Our ref: E5301

CAMDEN: 103 KING'S CROSS ROAD LONDON WC1X 9LP

2022/2623/P: Construction of 4th floor mansard roof extension; to provide, 1 bedroom self-contained dwelling, with recessed terrace.

Initial Proposal

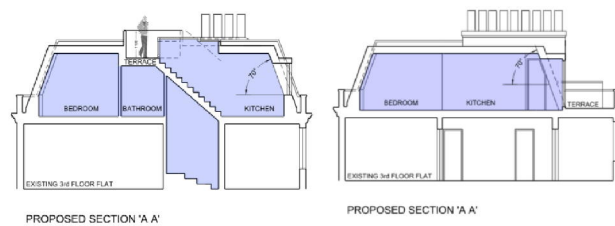
4. The section comparisons below show the angle of the mansard is unchanged and it remains a flat-topped modern mansard in style.

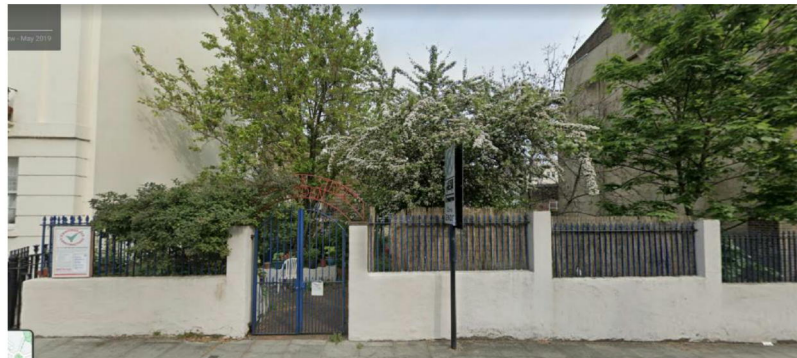
5. We agree with the Conservation Officer's response that *the host building has a vertical emphasis marking its corner location, largely deriving from proportions of its facades which are characterised by tall sash windows and also by the central corner chimney and eastern chimney which rise noticeably above the main parapet. This gives the building an appropriate status within the townscape which does not need to be further extended or emphasised and which strikes a balance with the adjacent building heights including the front parapets and roof forms of the grade II listed townhouses.*
